Subject: Class I Permit Application by Miami-Dade County to Trim and Alter Mangroves in a Coastal Band Community at the Vizcaya Museum and Gardens in the City of Miami

Subject: Class I Permit Application by Miami-Dade County to Trim and Alter Mangroves in a Coastal Band Community at the Vizcaya Museum and Gardens in the City of Miami

Vizcaya Museum and Gardens South Canal Restoration - Phase 1

Miami-Dade Project Number: EDP-VZ-VZ065

MANGROVE MITIGATION PLAN

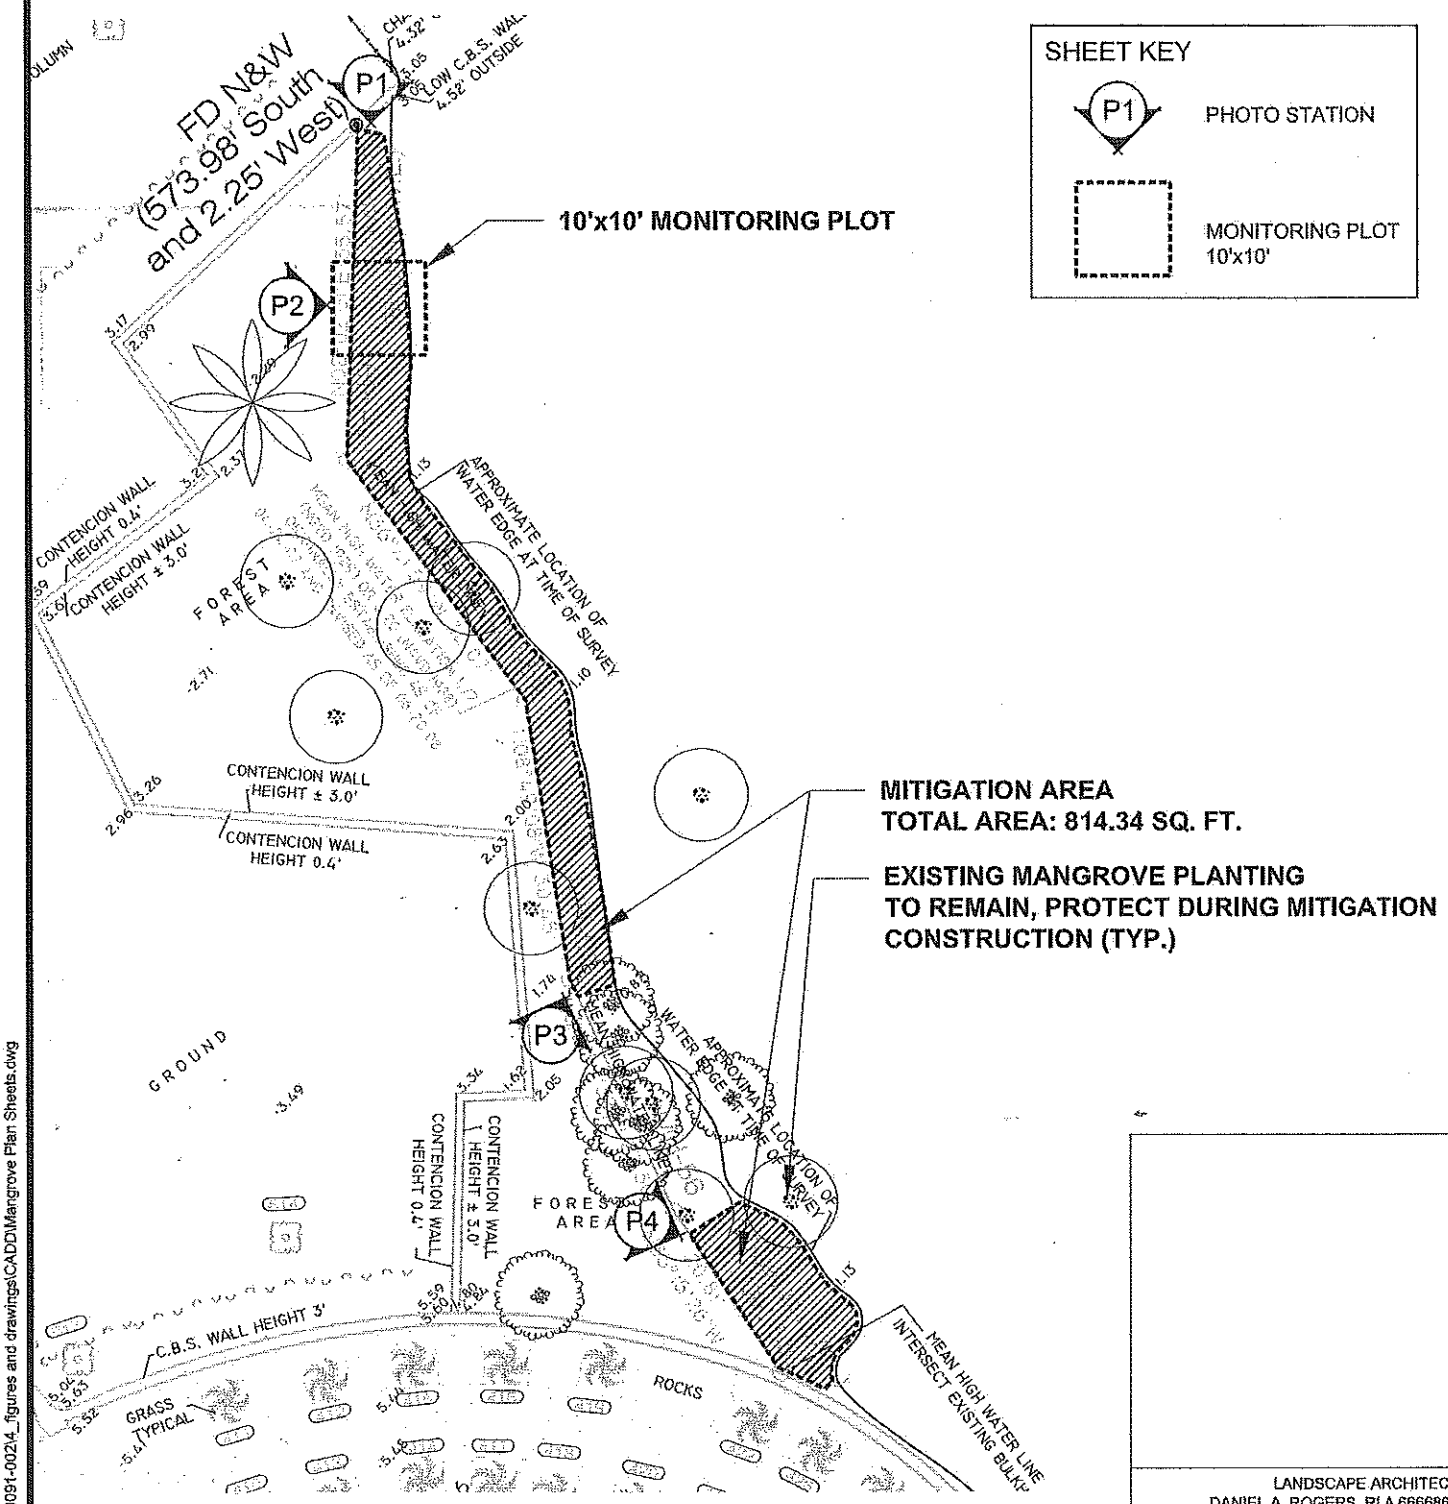
The applicant is proposing to mitigate on-site through the planting of red mangrove seedlings to restore an 814 square foot area within an existing halophytic wetland system, along the north corner of the property. The Class I permit will include specific conditions that require the mitigation area to be monitored for success, managed appropriately, and maintained free of exotics in perpetuity. No benthic resources were documented within the canal in the areas of the proposed maintenance dredging; therefore, no mitigation for this portion of the work is required.

Objective 1/Policy 1E - Mitigation for the degradation and destruction of coastal wetlands. Monitoring and maintenance of mitigation areas. – To mitigate for the removal of 814 square feet of mangrove canopy, the applicant shall plant red mangrove seedlings on-site. The Class I permit will include specific conditions that require the mitigation area to be monitored for success, managed appropriately, and maintained free of exotics in perpetuity.
